HISTORIC AND DESIGN REVIEW COMMISSION

HDRC CASE NO: 2024-334
ADDRESS: 106 OAKMONT COURT
LEGAL DESCRIPTION: NCB 6580 BLK 1 LOT 8 9 & 10
ZONING: R-5, H
CITY COUNCIL DIST.: 1
DISTRICT: Monte Vista Historic District
APPLICANT: John Franklin/Studio8 Architects
OWNER: Jeffery Meischan/TRINITY UNIVERSITY
TYPE OF WORK: Exterior alterations, fenestration modifications, site and landscaping work, non-original window replacement, driveway installation, signage
APPLICATION RECEIVED: September 16, 2024
60-DAY REVIEW: November 15, 2024
CASE MANAGER: Edward Hall

Historic and Design Review Commission
Pre-Submittal Consultation Report

Historic and Design Review Commission
Design Review Committee Report

LEVEL 1 - PORTE COCHERE - DEMO **1**

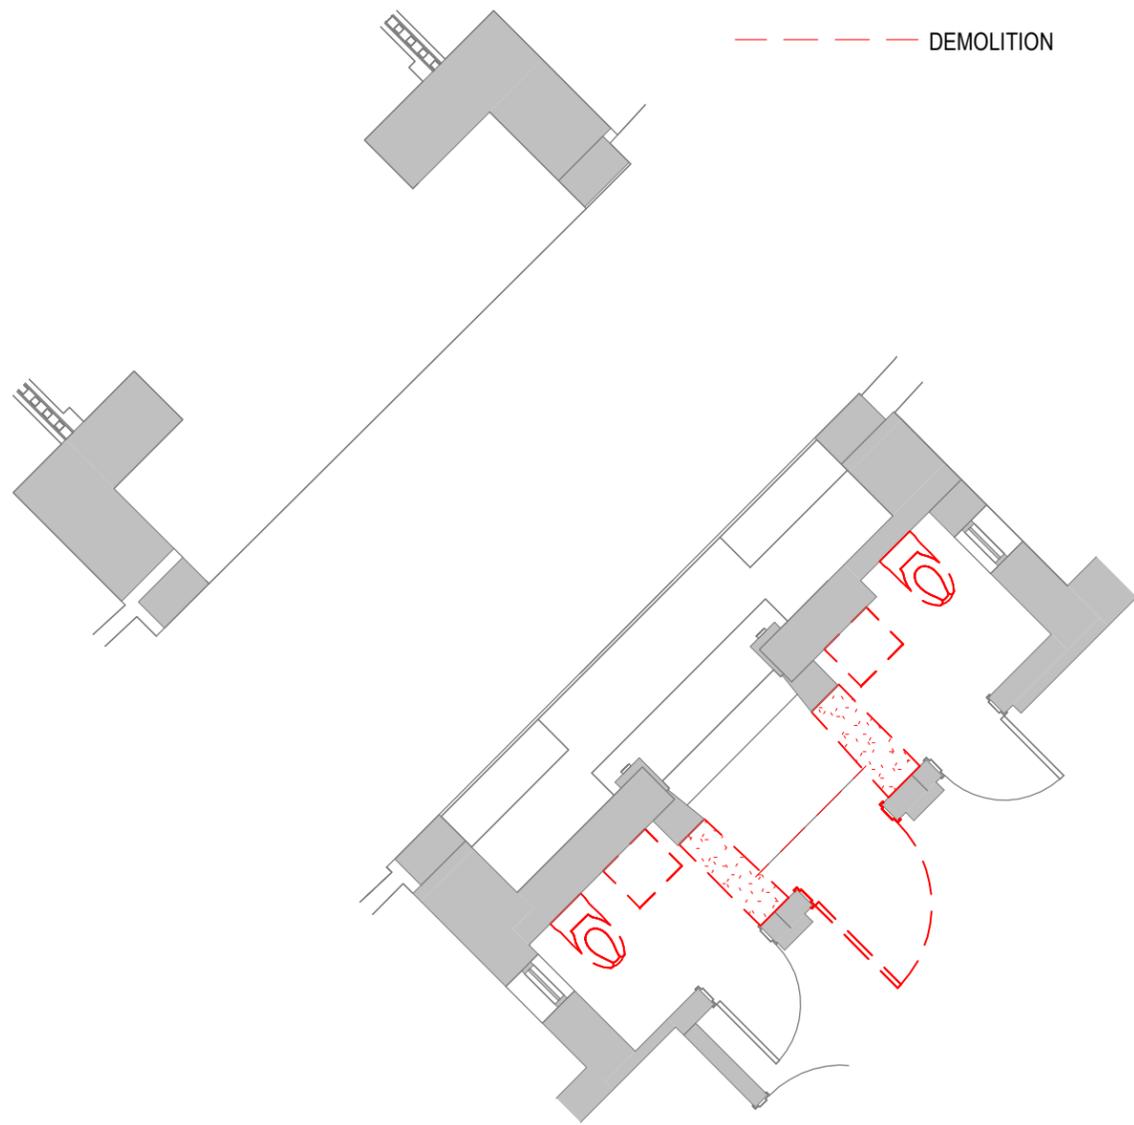
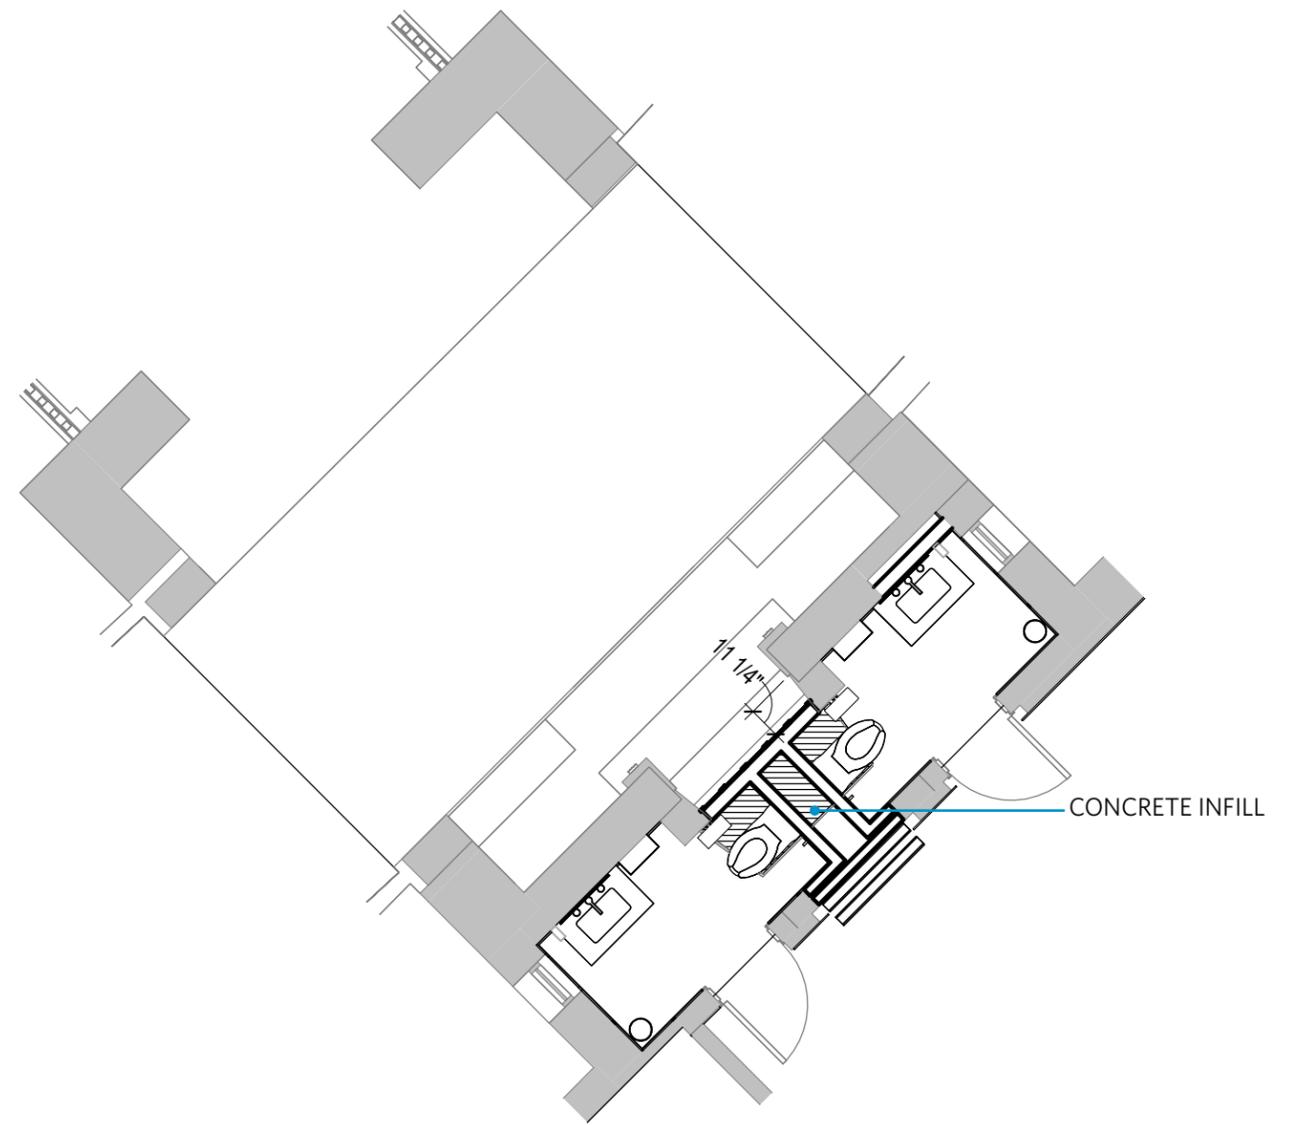
- f. DOOR OPENING Modification (Porte Cochere) – The applicant has proposed to modify an original door opening within the porte cochere by reducing the depth of the original vestibule and bringing the door to just within the threshold. The existing threshold moldings, stairs, and door hardware will remain, and the existing door panel will be reused. The moldings immediately adjacent to the door will be replicated at the proposed new door location. The Guidelines for Exterior Maintenance and Alterations 6.A.i. notes to preserve existing window and door openings and to avoid filling in historic window and door openings on the primary façade or where visible from the right of way. Generally, staff finds the applicant’s approach to preserving the opening to be appropriate. Staff finds that all decorative molding should be preserved and that the molding immediately around the door in its current location should be replicated. Additionally, staff finds that the step profile should not change and that the original door and its hardware should be reused.

JF: Overview of proposed door modification within the porte cochere; greater recess to express original opening

LG: Revised door location is an improvement; it does look better than the previous proposal which was bringing the door to the front of the opening

JF: Finds it to be an improvement as well, but whatever can be done to not have the door at the nose of the step would be better (at least 6 inches or half a tread width). Is there a reason why the other detail is not being replicated (plaster surround). MM: The intent would be to replicate this element; currently carved stone.

JF: The door detail needs a jamb; maintain the stone surround.

1. Staff recommends approval of item #1, the modification to an original door opening within the porte cochere based on finding f with the following stipulations:

- i. That all decorative molding be preserved and that the molding immediately around the door in its current location should be replicated at the proposed new threshold.

- ii. That the step profile not change and that the original door and its hardware should be reused.
2. Staff recommends approval of item #2, the enclosure of a side porch based on finding g with the following stipulations:

NORTHWEST - FRONT ENTRANCE INFILL - DEMO **2**
1/8" = 1'-0"

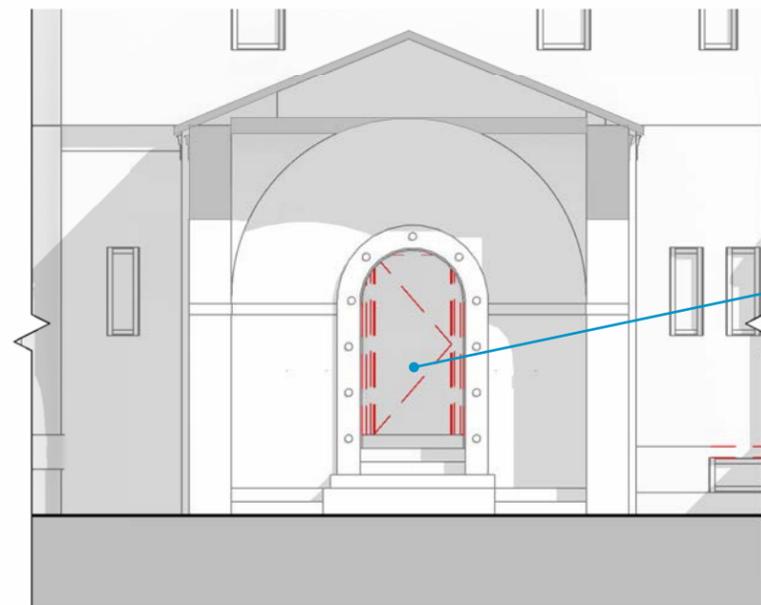
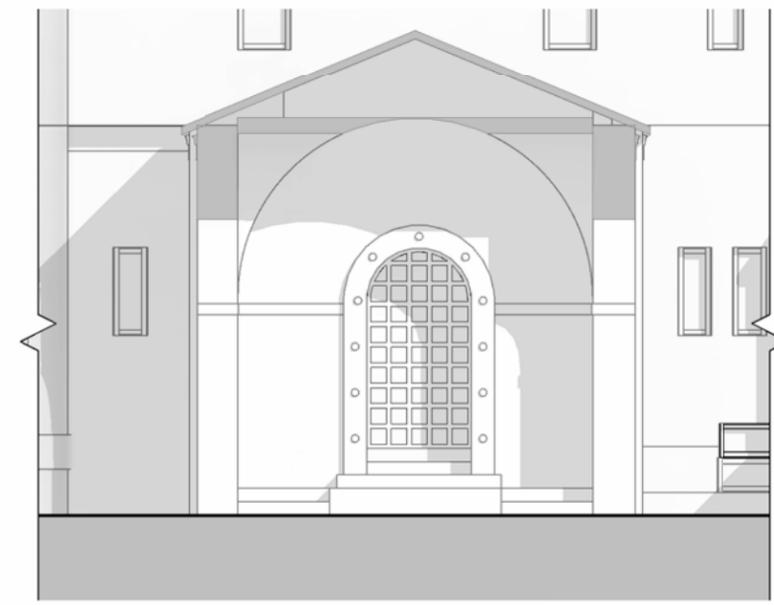
MS: Questions about front door impacts and how that relates to the proposed modifications. Concerns with modifications to the existing door profile; the door should still read as a door opening. It should be recessed to remain visible as a door.

JF: Agrees with MS regarding door at porte cochere. Concerned about wholesale replacement of windows. More information is needed to determine the requirement for

- questions about overall scope
- Previous discussion as being able to read as an entry way (MS), push door back slightly more.
- Bottom two steps would be exposed.
- Infill of door is specifically for modification to interior space
- Concerns about cutting into existing opening walls (JC)
- How was molding assembled? (MS) - clay tile.

NEW MOLDING TO MIMIC EXISTING MOLDING

EXISTING PANEL TO REMAIN AND BE RELOCATED CLOSER TO EXTERIOR WALL PROVIDING NEW INTERIOR SPACE FOR RESTROOMS

EXISTING HARDWARE TO REMAIN

EXISTING STAIR DETAIL TO REMAIN

LEVEL 1 - PORCH ENCLOSURE - COMPLETED **1**
3/16" = 1'-0"

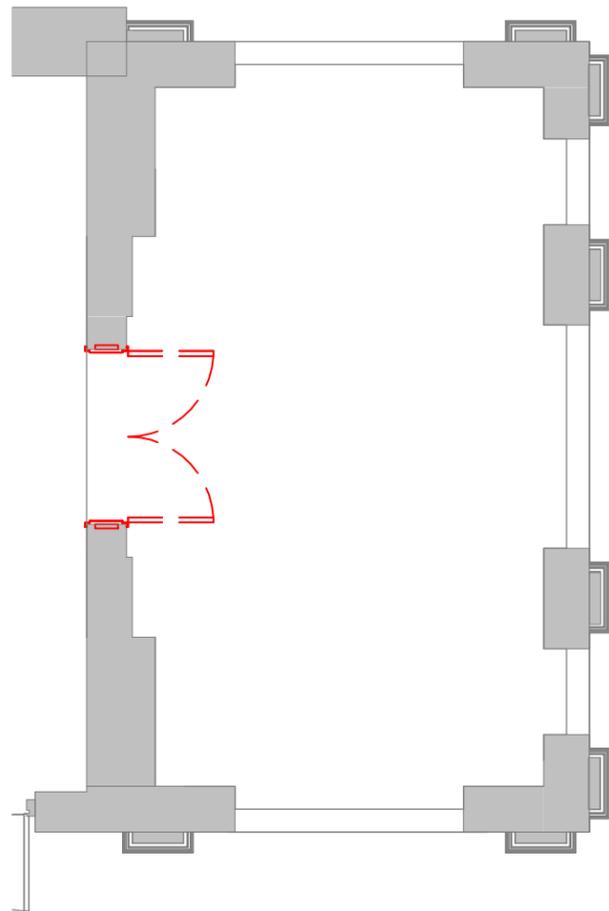
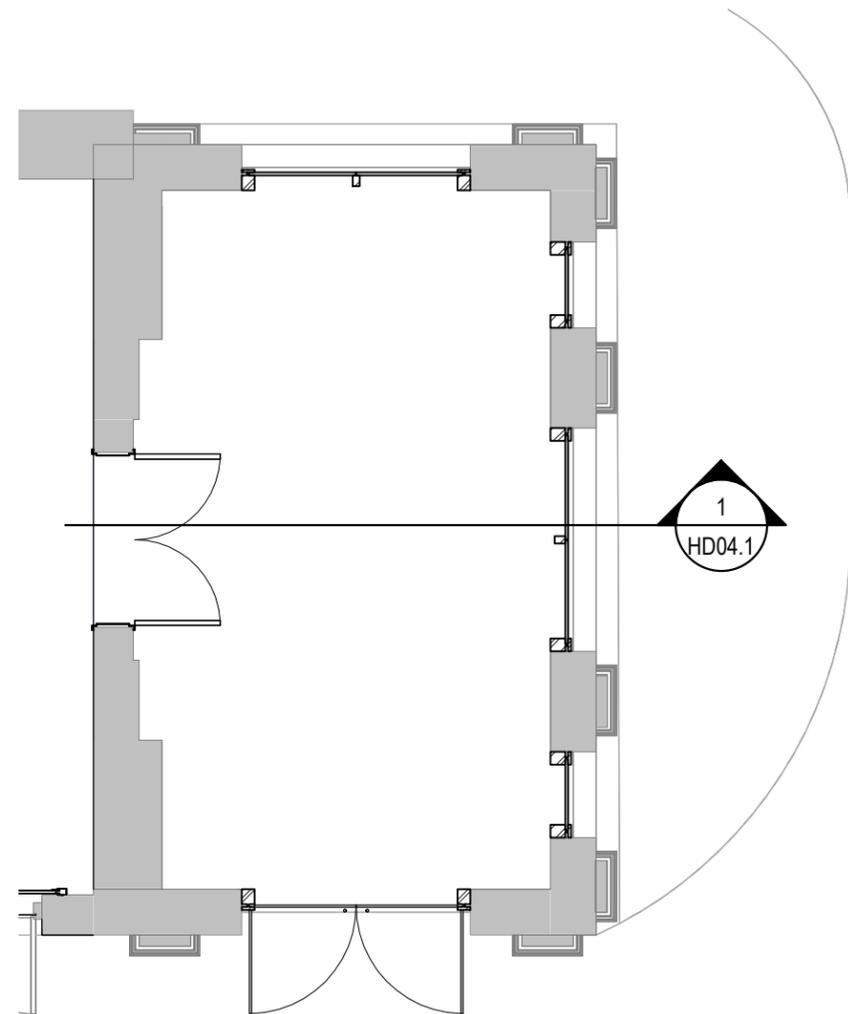
- g. SIDE PORCH ENCLOSURE & DOOR REPLACEMENT– The applicant has proposed to enclose an existing, side porch on the east wing of the historic structure and to replace an existing door. The proposed enclosure will feature glass curtain walls installed with a recess from the front face of the existing columns. The proposed door that is to be replaced does not appear original and will be replaced with a new, wood door. The Guidelines for Exterior Maintenance and Alterations note to refrain from enclosing side and rear porches; however, the Guidelines note that alterations to side and rear porches should result in a space that functions, and is visually interpreted as, a porch. Staff finds that the applicant has proposed an enclosure that allows the side porch to continue to appear as a porch. The applicant has proposed a system that will be void of exterior muntins and will allow the curtain wall to appear as minimal in profile as possible, and a recess of eight to ten inches within the existing openings. Staff finds the proposed installation depth to be appropriate and door replacement to be appropriate.

JF: Questions about enclosed porch – will openings remain? Enclosure should be reset within the masonry opening so that the depth of the historic openings read as prominent. MS: Agrees.

MS: Concerns that infill windows/doors at side porch appear as storefront. MM: Final design and profile will not appear as so.

- space is to be enclosed for event prep space
- Infill should not appear as commercial storefront
- Discussion regarding replication of existing window profiles. More vertical emphasis than horizontal. (Divided Lites) - MS and RM
- Frameless appears to be non-historic (LH)
- MS- Consider recessing behind columns
- Floor will be raised to match interior finish floor height.

- i. That final details of the storefront system be submitted to OHP staff for review and approval. The hardware, muntins, and mullions should feature a finish that matches those found on historic hardware on site.

SOUTHEAST ELEVATION - ELEVATOR WALL INFILL 2
 1/8" = 1'-0"

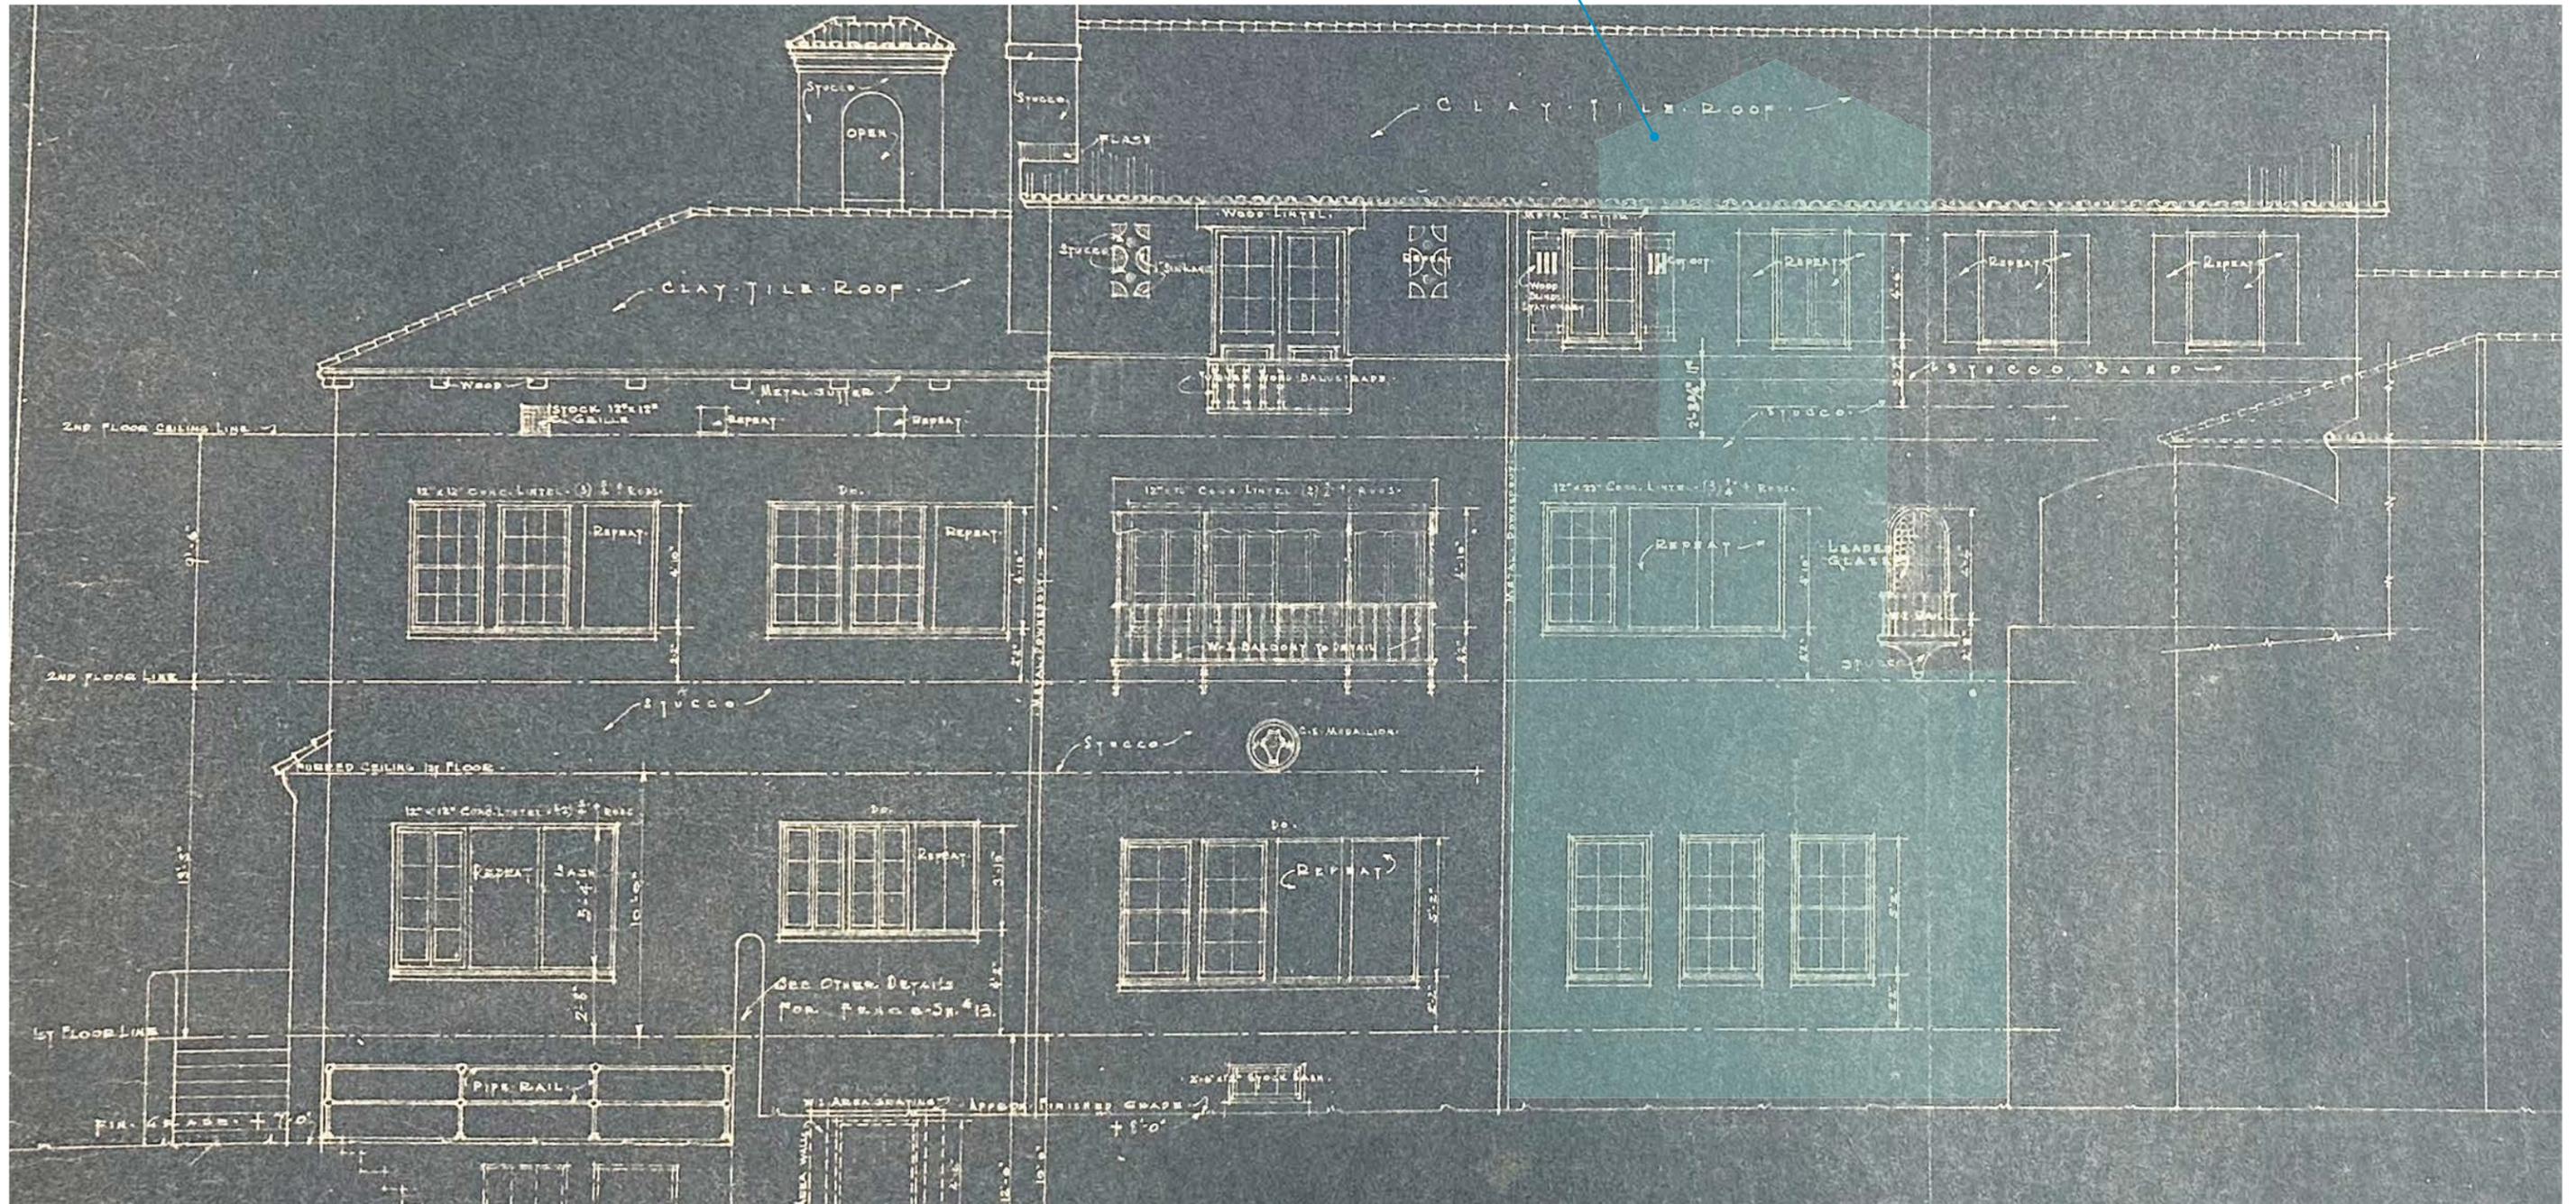
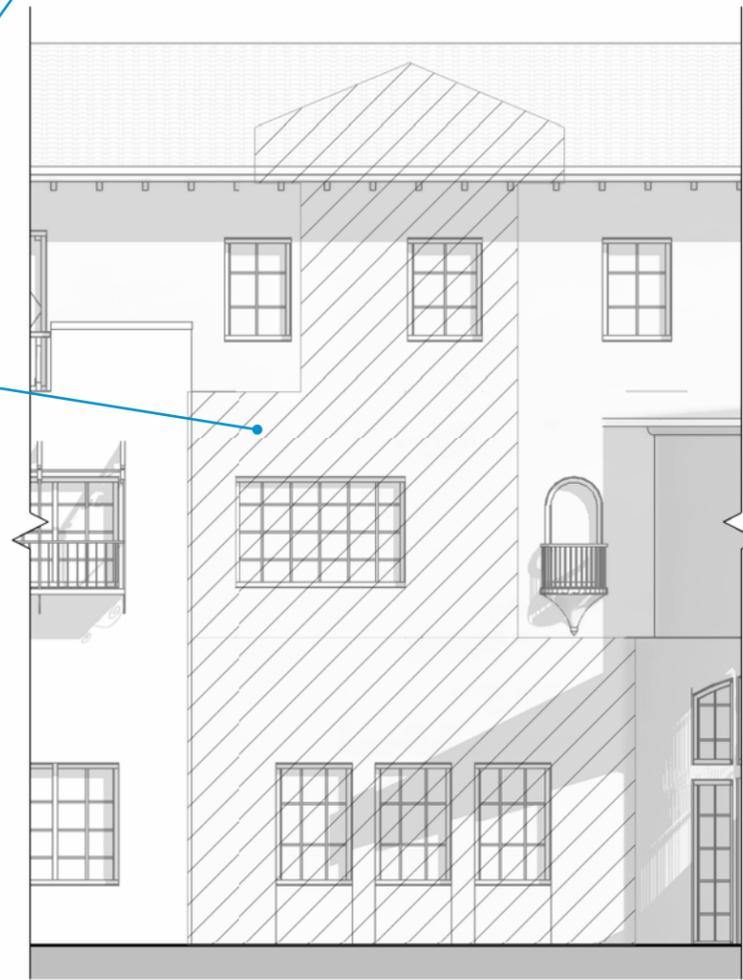
- h. FAÇADE RESTORATION (Location of Elevator Removal) – The applicant has received approval to remove an 1980’s elevator addition at the rear of the historic structure. Once removed, the applicant has proposed to restore the façade to its original condition. The applicant has submitted a rear elevation noting the original

design; staff finds that all original window openings should be reintroduced in the profile shown. This include the installation of true mullions between grouped windows.

3. Staff recommends approval of item #3, the restoration of the rear façade to its original condition based on finding h with the following stipulations:

- i. That all original window openings should be reintroduced in the profile shown on the original construction documents. This includes the installation of true mullions between grouped windows and stucco finish.
